INNER WEST

DEVELOPMENT ASSESSMENT REPORT

Application No.	DA/2021/0866
Address	11 Phoebe Street BALMAIN NSW 2041
Proposal	Alterations and additions to dwelling including extension of upper level.
Date of Lodgement	16 September 2021
Applicant	PERFECT SQUARE DESIGN PTY LTD
Owner	Mr Craig S Barnett Mrs Renate C Barnett
Number of Submissions	Initial: 2
Value of works	\$278,000.00
Reason for determination at Planning Panel	Floor Space Ratio variation greater than 10%
Main Issues	<ul style="list-style-type: none"> • Floor Space Ratio development standard variation • Heritage Impacts • View Loss
Recommendation	Refusal
Attachment A	Reasons for Refusal
Attachment B	Without Prejudice Conditions of Consent
Attachment C	Plans of proposed development
Attachment D	Clause 4.6 Exception to Development Standards
Attachment E	Statement of Heritage Significance

Figure 1: View corridor of No. 2-4 Phoebe Street, facing towards Parramatta River

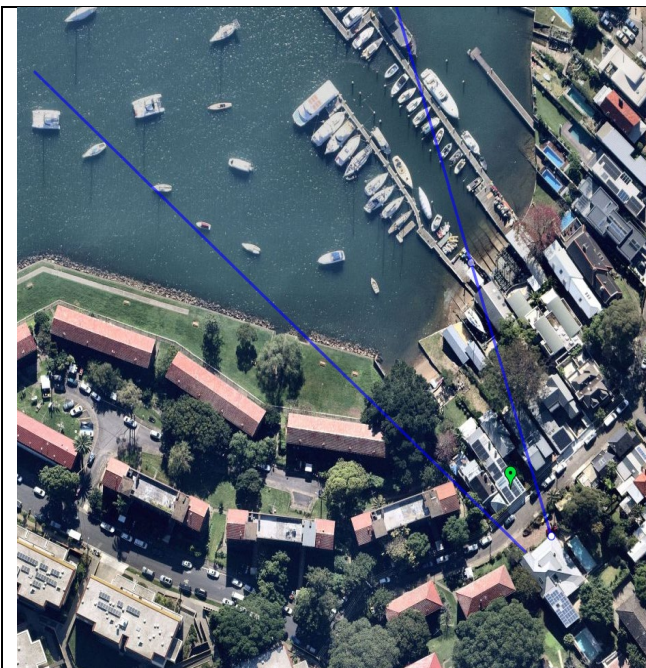
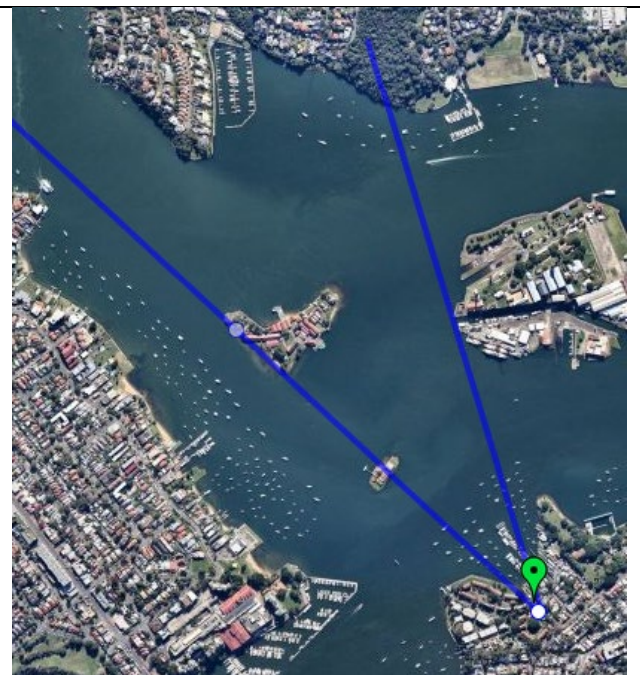
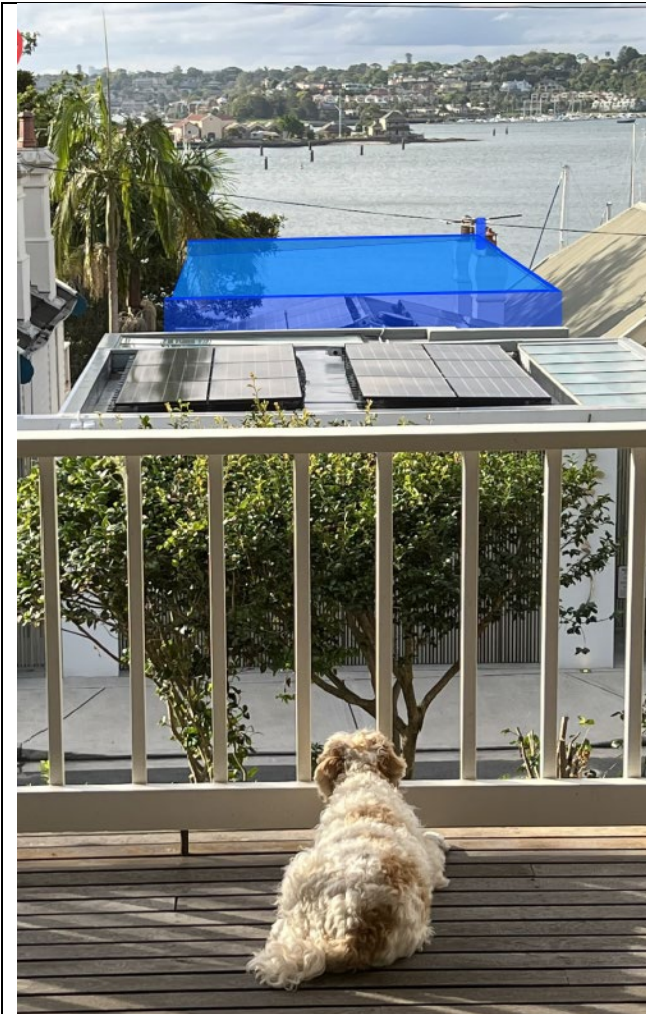
Comment: As noted in the photos above, views are currently obtained from the front of the property (north-west facing) lower ground floor living/dining room, upper ground floor formal living/dining area, upper ground floor verandah and first floor balcony connected to a bedroom. – the views include views of Spectacle Island and Parramatta River. Notwithstanding, majority of the views of Parramatta River and Spectacle Island will be maintained – see photos above and further commentary below.

Comment: The views (see pictures above) are obtainable over the roof structure of 11 Phoebe Street when standing up against the lower ground, upper ground floor living/dining area windows and first floor balcony. In addition, the views obtained in photo 4 are from the verandah located on the upper ground level and on the north eastern end, adjoining the upper ground floor living area.

Comment: The existing views of Spectacle Island and Parramatta River are enjoyed and obtained from all three levels as shown in the photos above on the lower ground, upper ground living areas, upper ground verandah and from the first floor balcony which is connected and servicing a bedroom.

02 NORTH-WEST PROPOSED ELEVATION 1:100

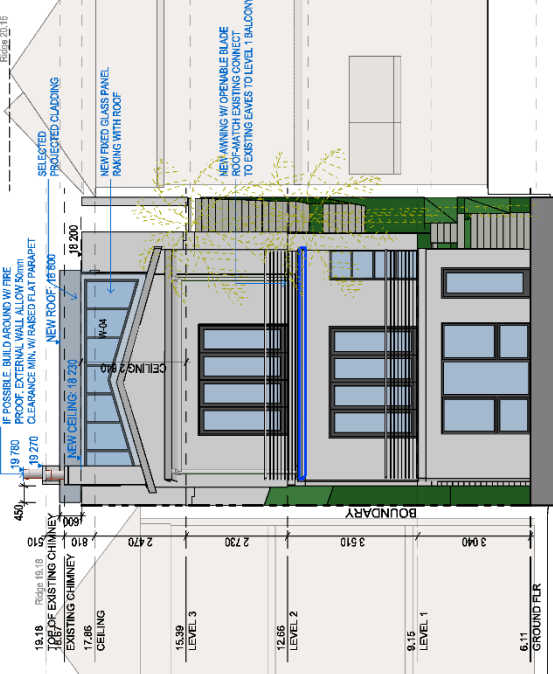
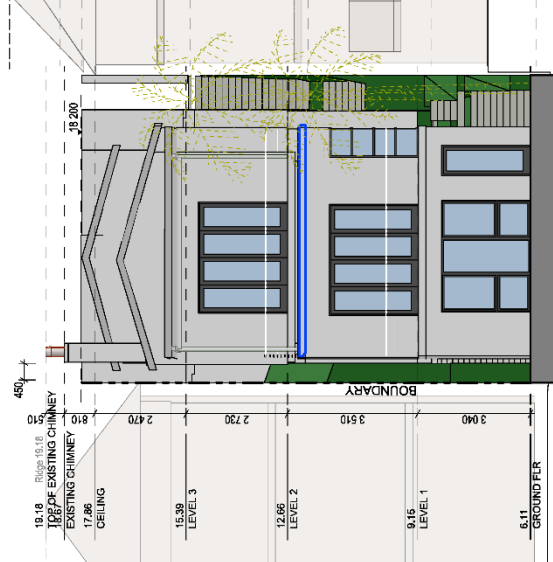
The proposed modification of the roof to demolish the significant chimneys and convert it to a flat-top roof addition with horizontally proportioned windows is inconsistent with Council controls and the context of adjacent properties, and will erode the heritage character of the site and conservation area.

Figure 3: North east elevation showing the proposed addition in blue

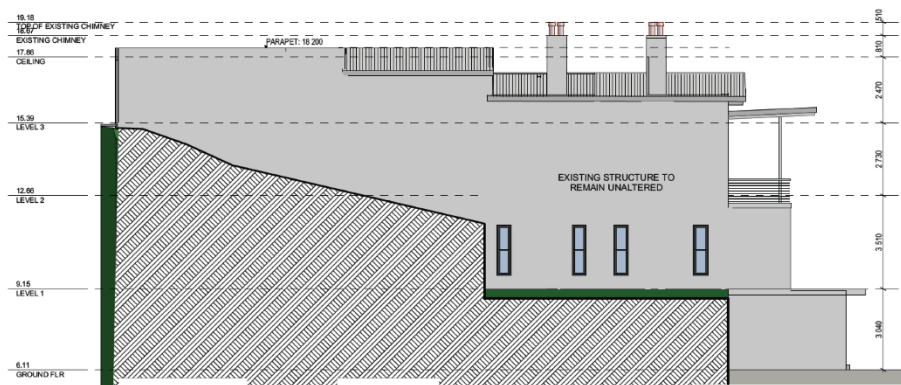
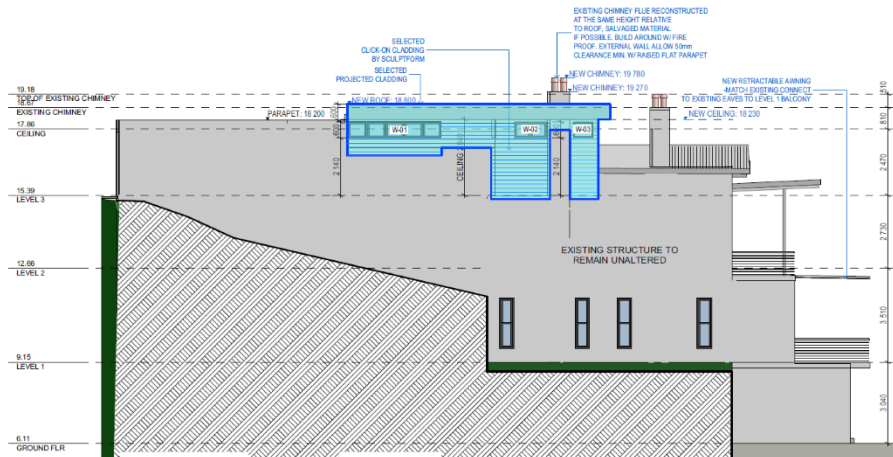
Comment: As per the submitted plans and Figures 1-2 above, the proposed variation does not impact upon the predominant bulk, scale, streetscape or character of the surrounding area. The proposed FSR variation maintains the low density residential character of the site and surrounding area. The amenity of the site and surrounding heritage conservation area is maintained to an appropriate standard.

Comment: The proposal including the variation to FSR has been skilfully designed without creating unreasonable bulk and scale impacts. Considering the site slope and other dwellings within the vicinity of the site, the proposal represents a similar form. The building retains the appearance as a single storey from the streetscape and the overall height is raised by 600mm only at the rear portion of the building subject to the addition (Refer to Figure 2 above).

Figure 3: Existing and proposed shadowing

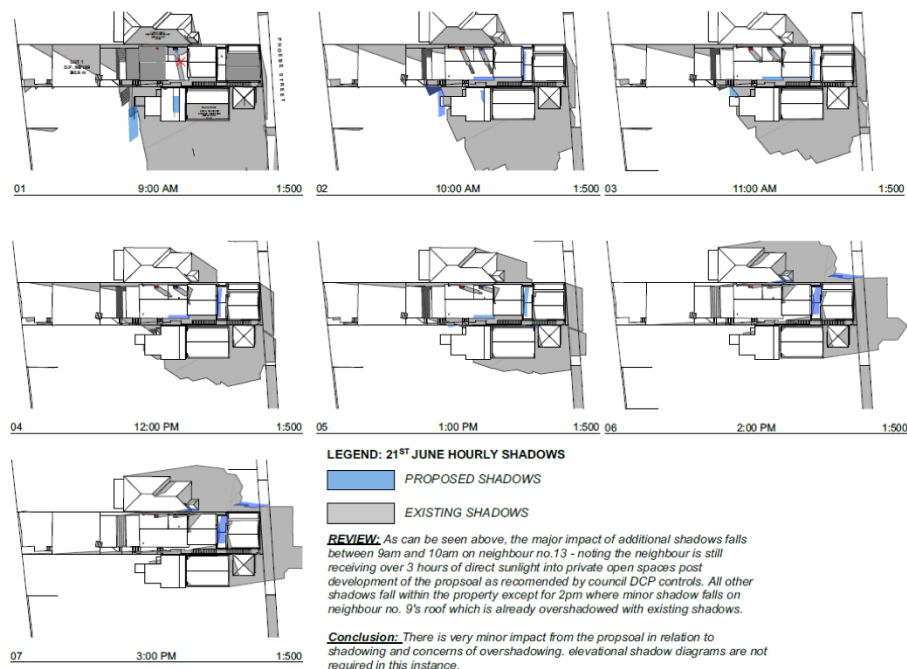
- No unreasonable shadowing impacts are proposed by the variation as demonstrated in Figure 3 below.
